Our Ref: TR/11146/jj

5 September, 2019

**RE: QANTAS FLIGHT TRAINING CENTRE (SSD 10154)**  
**RESPONSE TO TRAFFIC MATTERS RAISED IN FURTHER SUBMISSIONS**

Figure 1

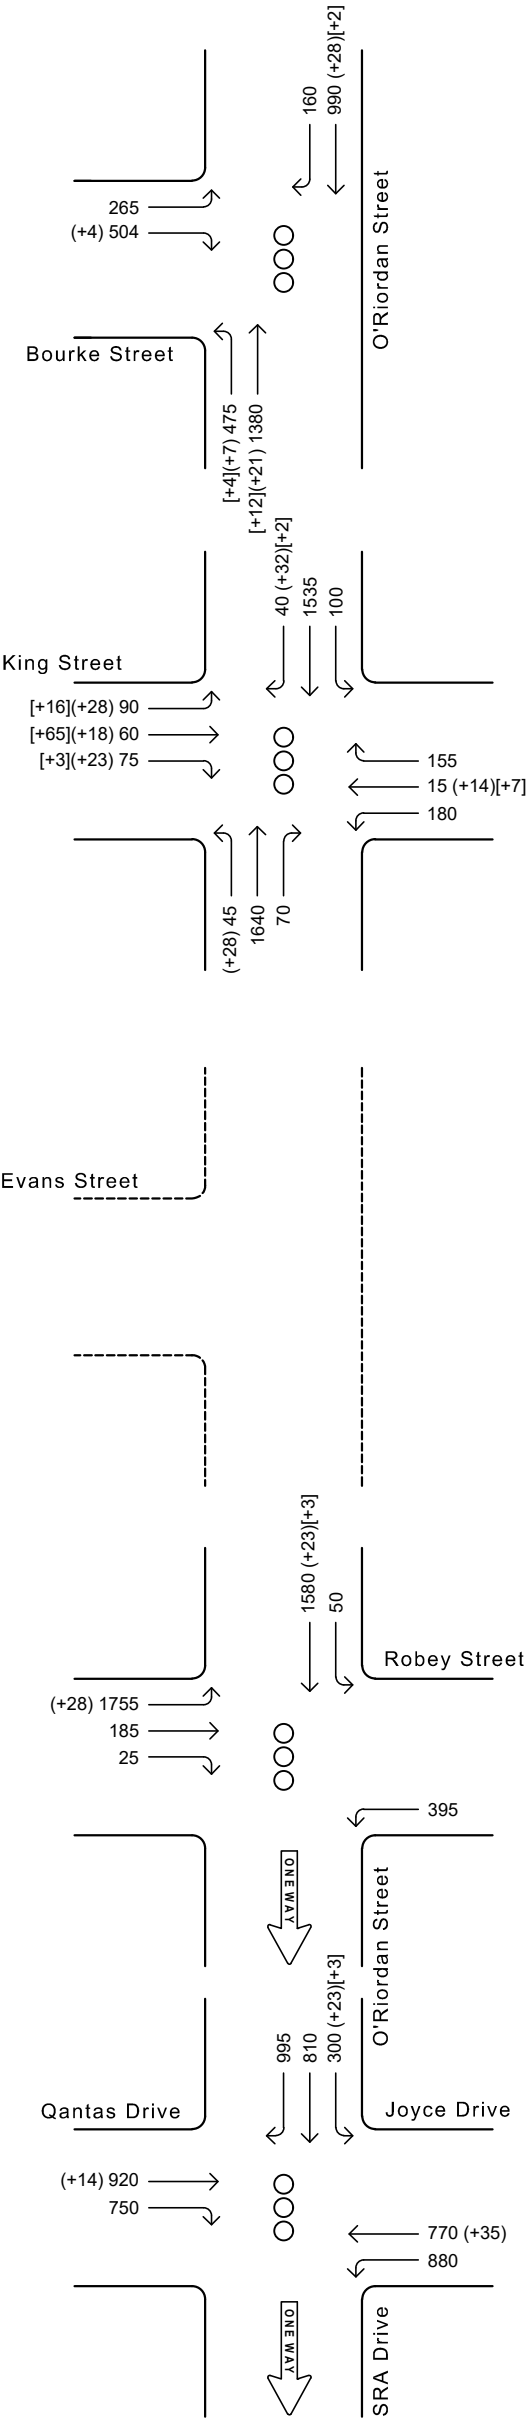
- *the SIDRA analysis be updated to include the following:*
  - *missing traffic flows at the intersection of King Street/O’Riordan Street;*
  - *increased cycle times at signalised intersections to be within the range 120 to 130 seconds to be consistent with SCATS data;*

3. The missing traffic flows through the King Street/O’Riordan Street intersection (48 vehicles in the AM peak hour and 40 vehicles in the PM peak hour) have been included in the updated SIDRA analysis and are shown in Figures 1 and 2.
